Subject: UniStar Nuclear Energy, NRC Docket No. 52-016  
Response to Request for Additional Information for the  
Calvert Cliffs Nuclear Power Plant, Unit 3,  
RAI No. 171, Ultimate Heat Sink - Raw Water Supply System

**Response to NRC Request for Additional Information  
RAI No. 171, Question 09.02.05-2, Ultimate Heat Sink - Raw Water Supply System,  
Calvert Cliffs Nuclear Power Plant, Unit 3**

**RAI No. 171, Question 09.02.05-2**

FSAR Figure 9.2-7 will be replaced with the following figure in a future COLA revision:

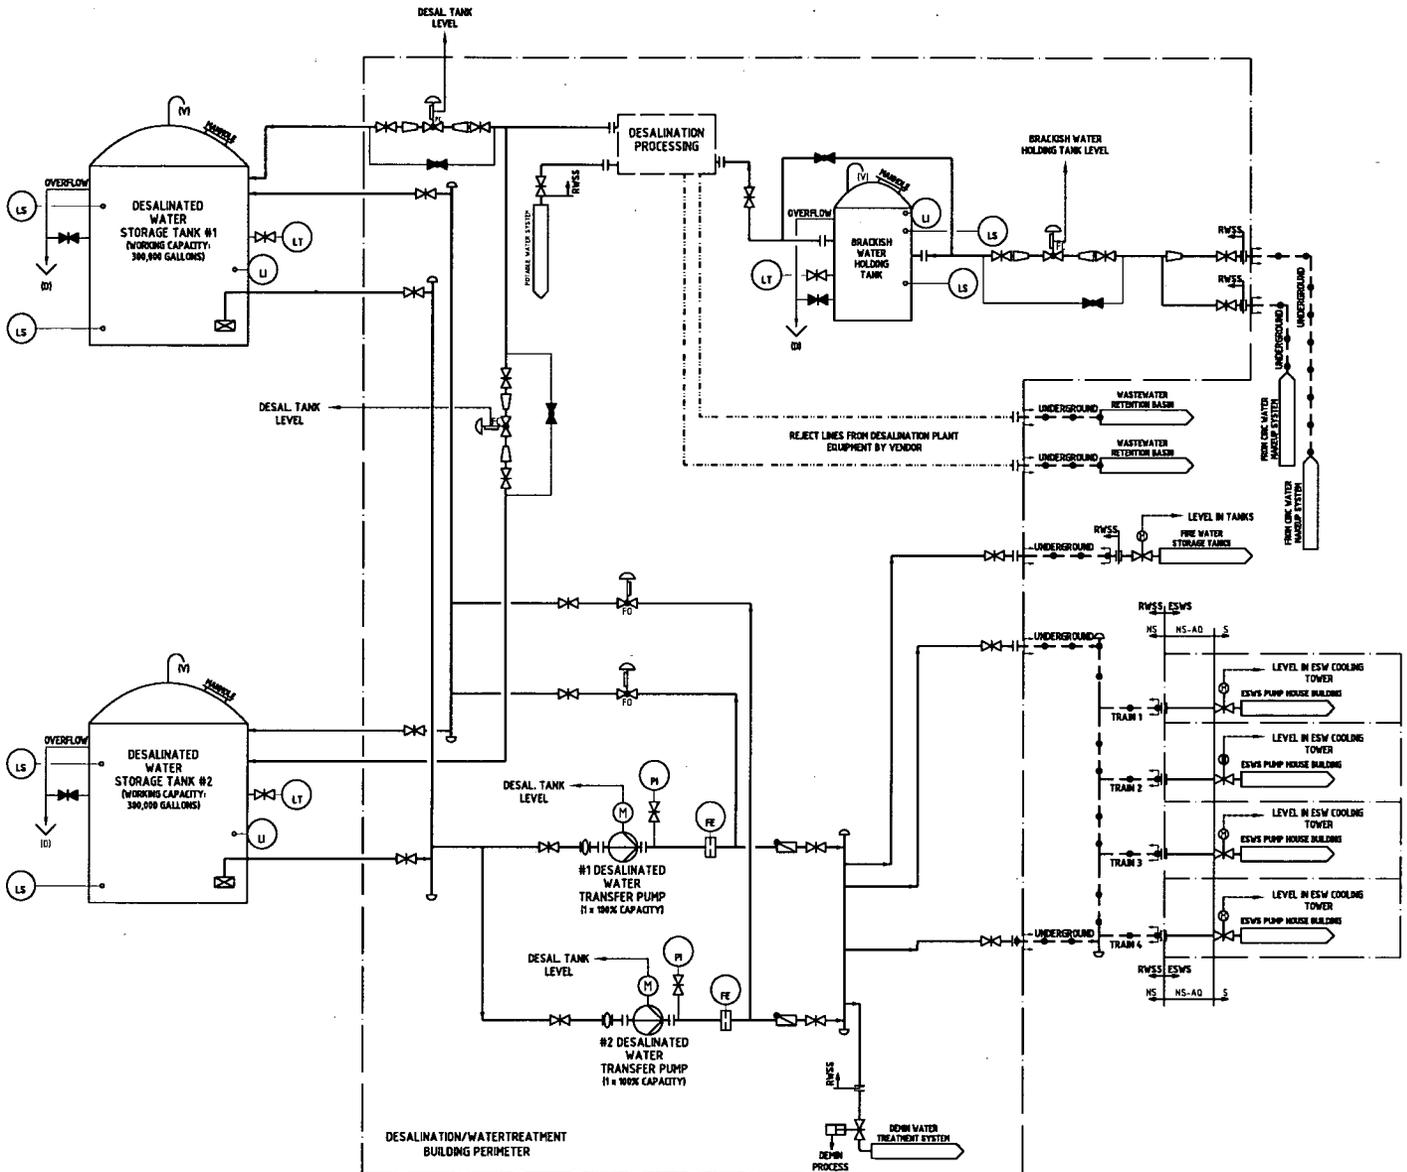
- RWSS piping materials, including buried piping materials, are not specified.
- Figure 9.2-7 does not provide specific locations of the RWSS equipment and major isolation valves to interfacing system, and does not indicate whether the system components are in the yard or buried.

7. Figure 9.2-7 does not provide specific locations of the RWSS equipment and major isolation valves to interfacing system, and does not indicate whether the system components are in the yard or buried.

FSAR Figure 9.2-7 will be updated to indicate the RWSS equipment and major isolation valves to the interfacing systems and, where a building is not indicated, the components (i.e., piping) are outside in the yard area or buried.

See updated Figure 9.2-7 in this Enclosure (COLA Impact page 41).
